REF: SUP25-0002 DATE: March 13, 2025

Request - Special Use Permit for a Hospital

Location - 3325, 3329, and 3350 Collingwood Boulevard

SITE PLAN

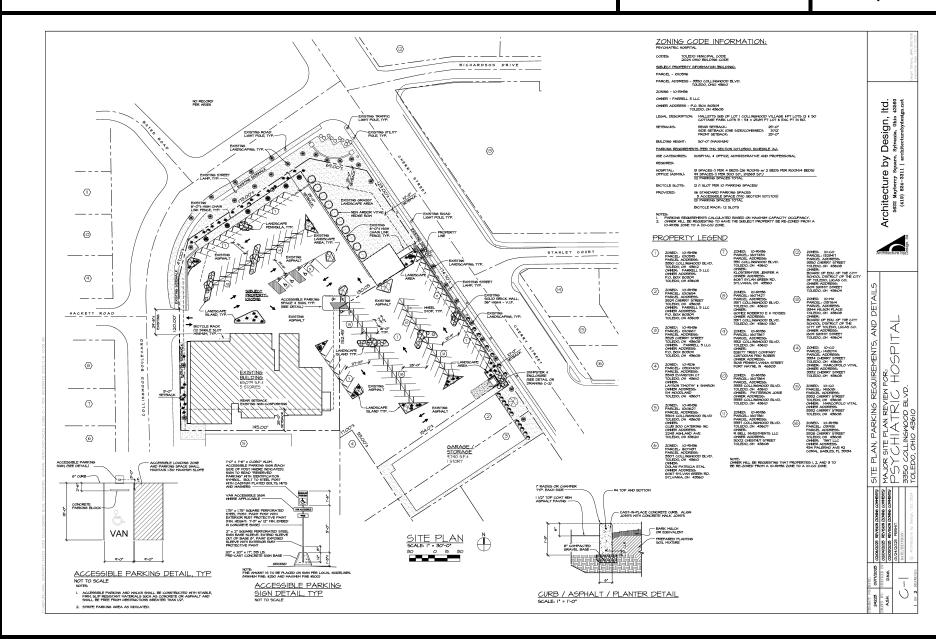
- 8. One (1) off-street loading zone space shall be provided with a minimum dimension of 12 by 35 feet per TMC§1107.1000. **Shall be depicted on a revised site plan.**

- 9. A minimum of five (5) accessible parking spaces for physically disabled persons is required. **Acceptable as depicted**
- 10. Parking spaces for physically disabled persons shall be in conformance with the standards of TMC§1107.1700. Site plan depicts required signage at six feet five inches (6' 5"), signage shall not be more than six feet (6') in height above pavement level.
